## Addendum 01

Date: March 27, 2002

To: Allied/Cook Construction, Inc.  
From: Ben Walter, CWS Architects  
Regarding: Exterior Renovations to The Park Danforth  
Subject: Addendum 01

Drawing Number:  
**SKA-1**

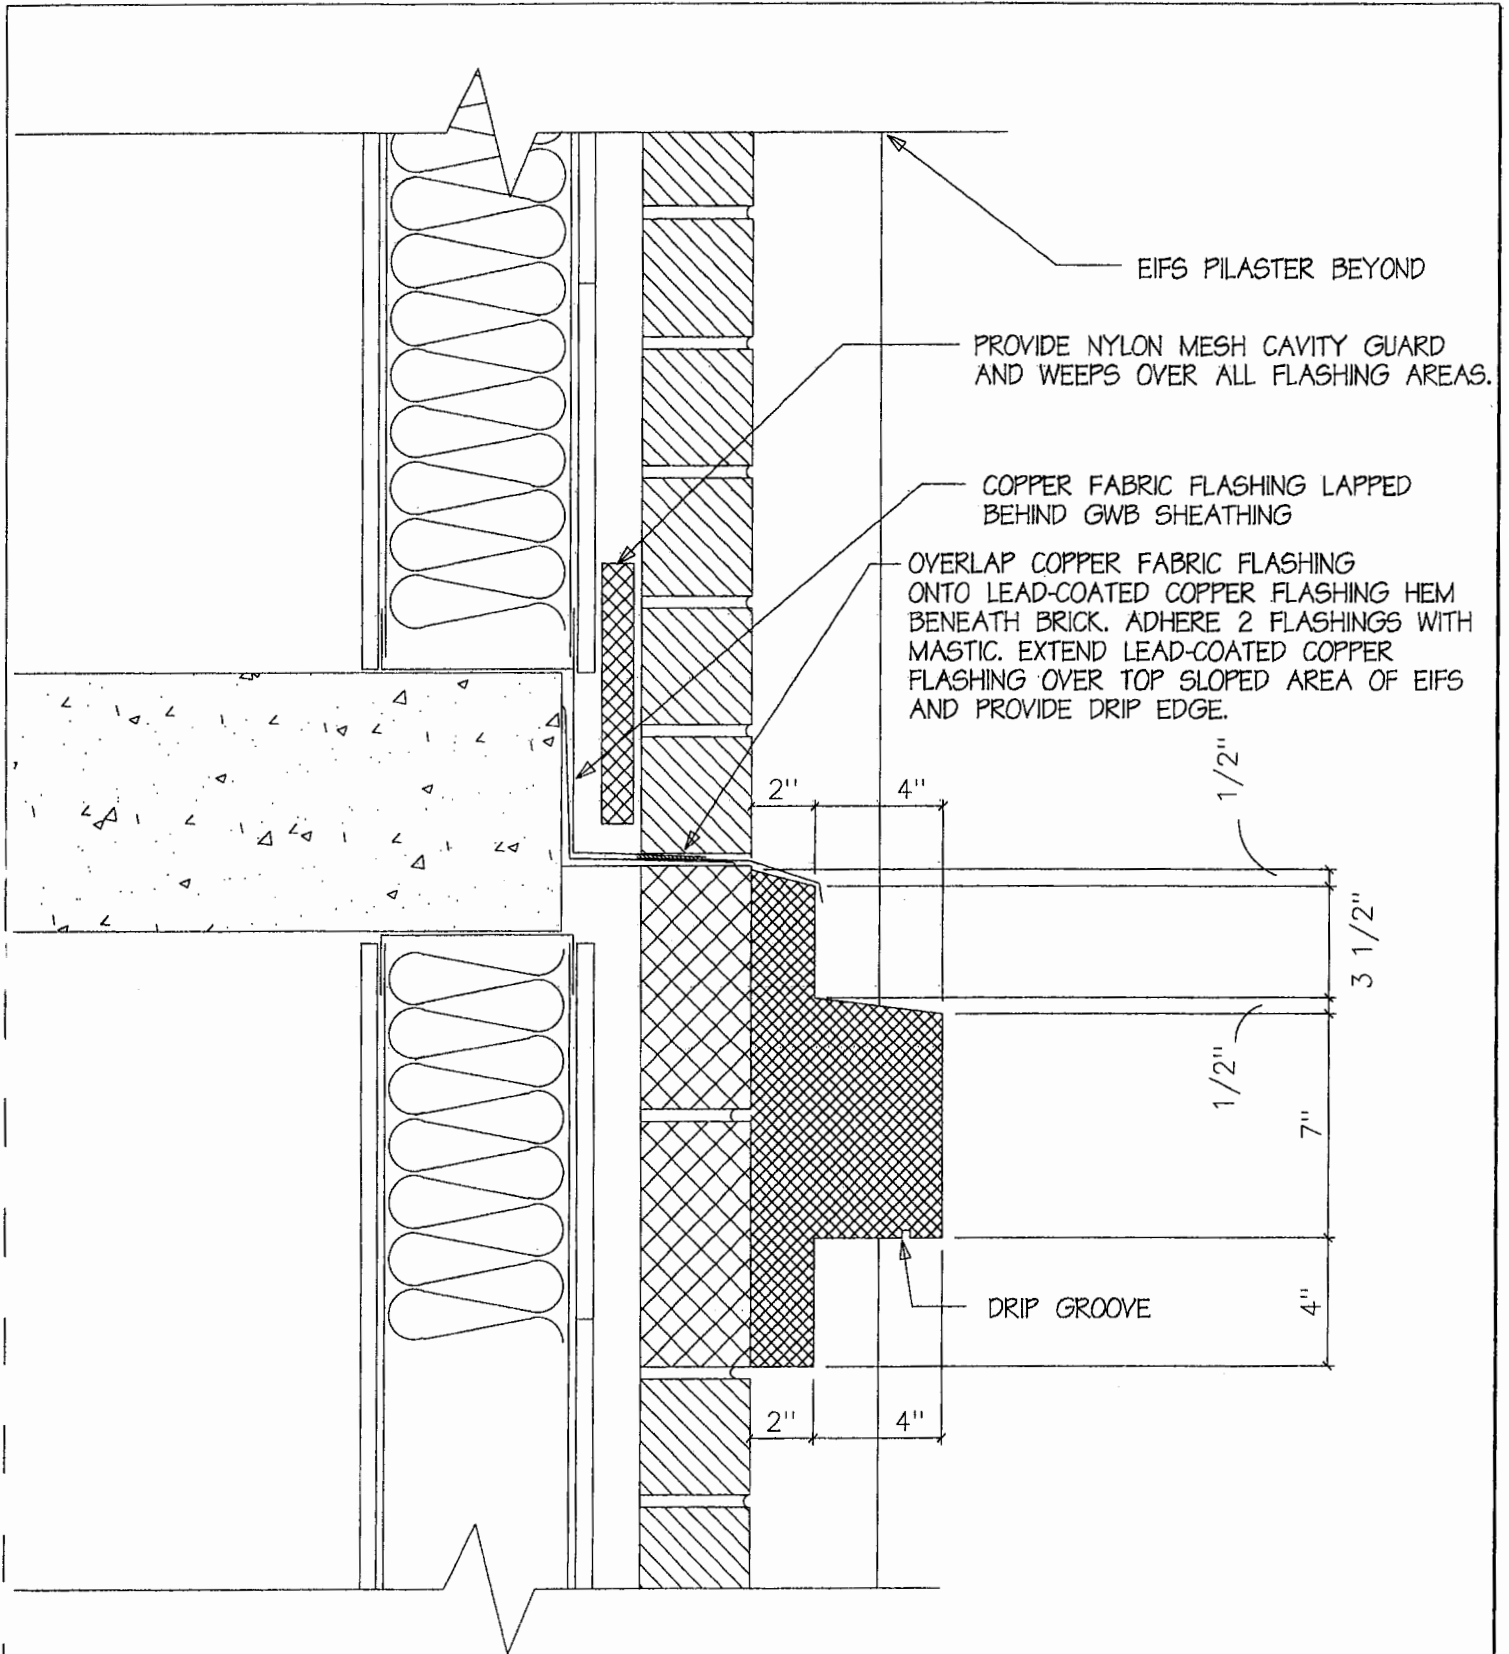
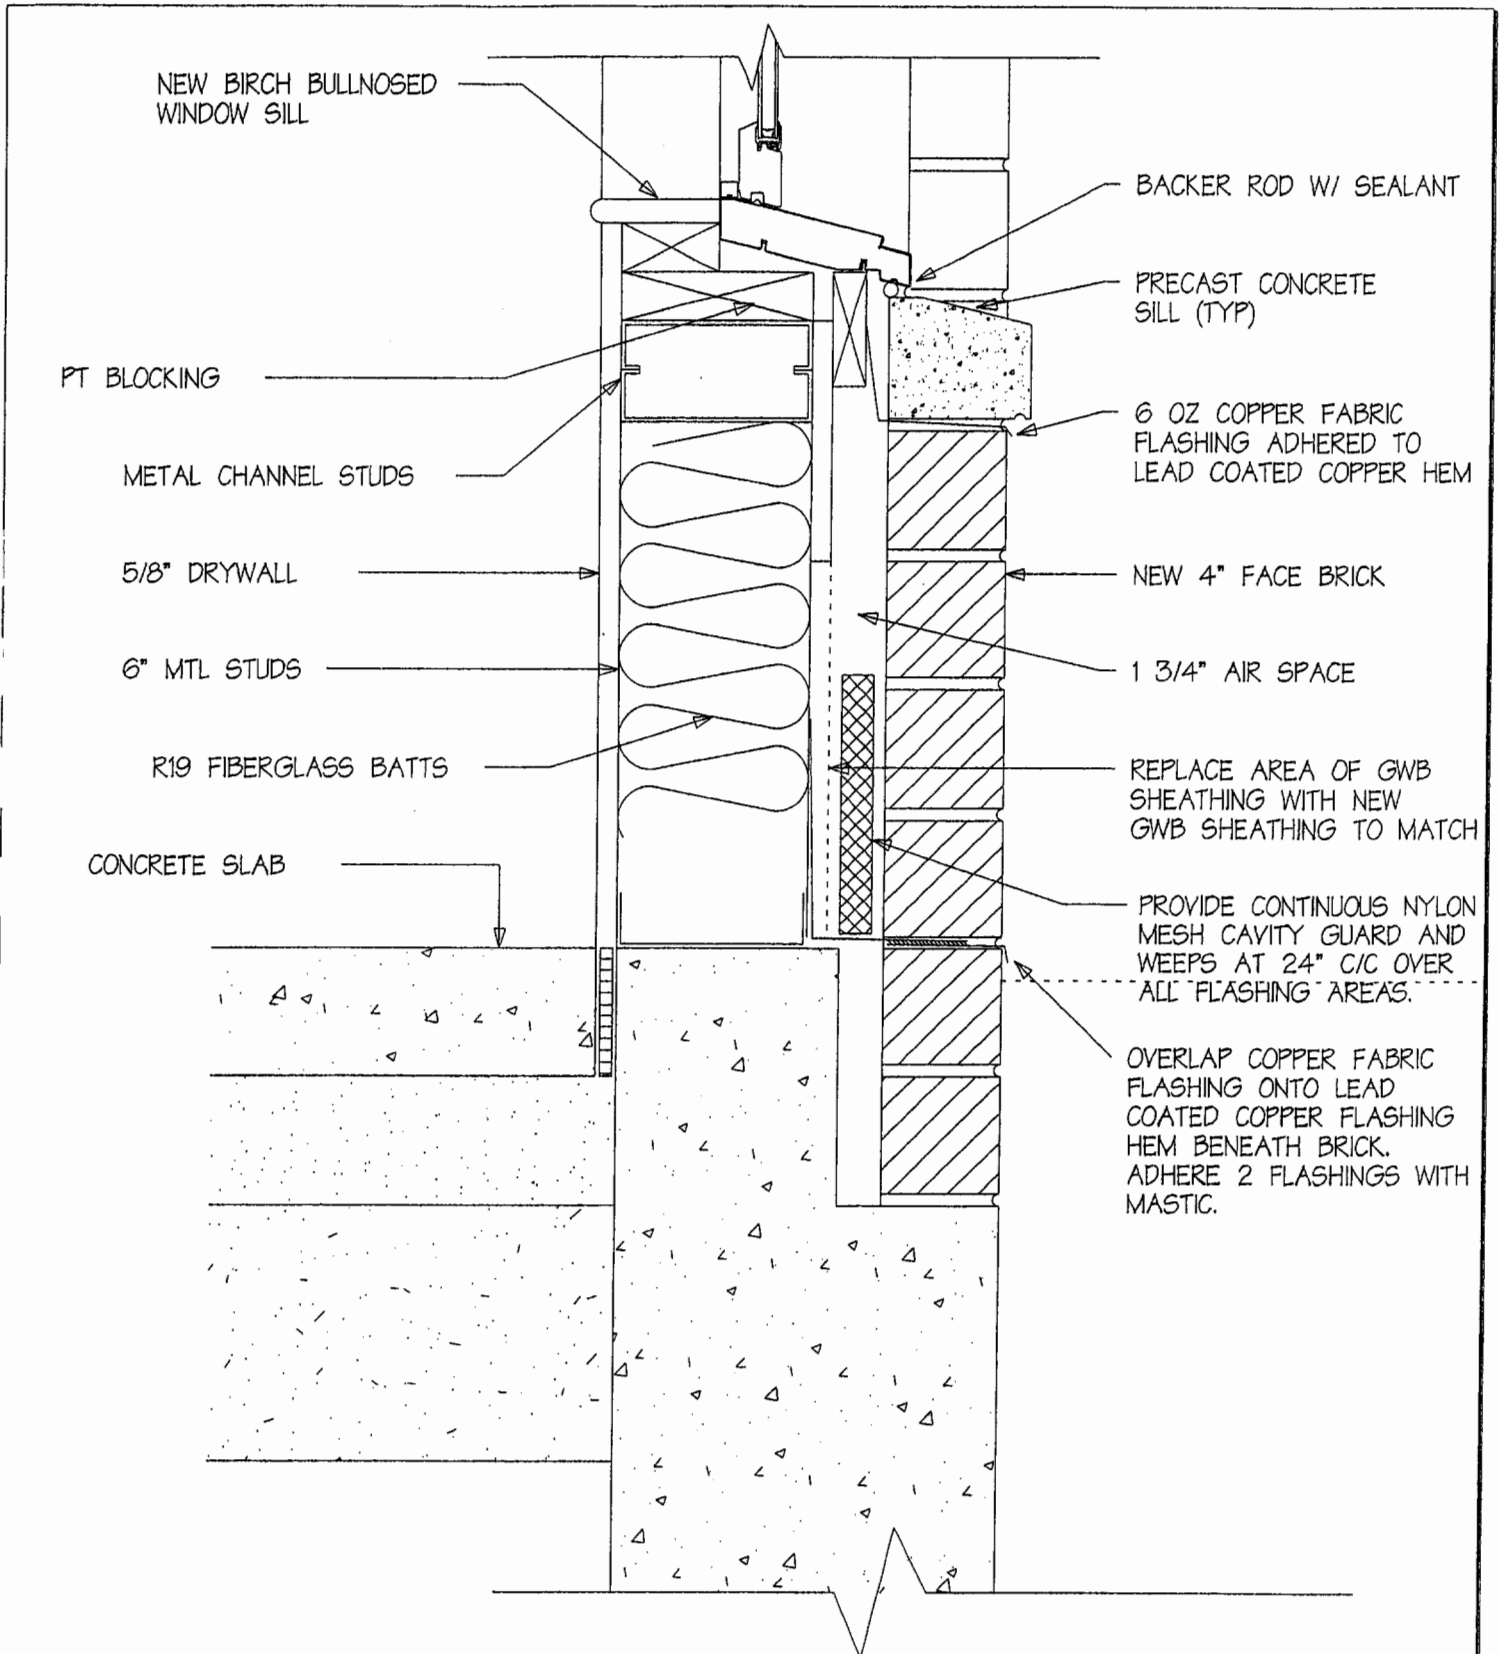
- New Handrails (Clean by SP-6)
  - New Relieving Angles (Clean by SP-6)
  - 1 Coat ICI "Devron" 201
  - 1 Coat ICI "Devthane" 389 Aliphatic Urethane Gloss Enamel
5. Provide Cav-Clear nylon mesh cavity guard and weeps as per attached specification and SKA-1 installed above the flashing at all brick bearing locations (foundation and relieving angles) to provide adequate weeping from cavity to exterior as follows:
  - Masonry Mat: Continuous, sizes as indicated within the drawings.
  - Manufacturers:
    - a. CavClear
    - b. Or equal

1. Both 16oz. lead coated copper and 5oz fabric flashing are specified at both the base of the building and at all relieving angles. All locations where "6oz flashing" is called out on the plans shall be changed to read "5 oz flashing" as indicated in the specifications. SKA-1 clarifies the installation of the flashing system at all masonry bearing locations.

PROVIDE NYLON MESH CAVITY GUARD AND WEEPS OVER ALL FLASHING AREAS.

OVERLAP COPPER FABRIC FLASHING ONTO LEAD-COATED COPPER FLASHING HEM BENEATH BRICK. ADHERE 2 FLASHINGS WITH MASTIC. EXTEND LEAD-COATED COPPER FLASHING OVER TOP SLOPED AREA OF EIFS AND PROVIDE DRIP EDGE.

PROVIDE CONTINUOUS NYLON MESH CAVITY GUARD AND WEEPS AT 24" C/C OVER ALL FLASHING AREAS.

OVERLAP COPPER FABRIC FLASHING ONTO LEAD COATED COPPER FLASHING HEM BENEATH BRICK. ADHERE 2 FLASHINGS WITH MASTIC.
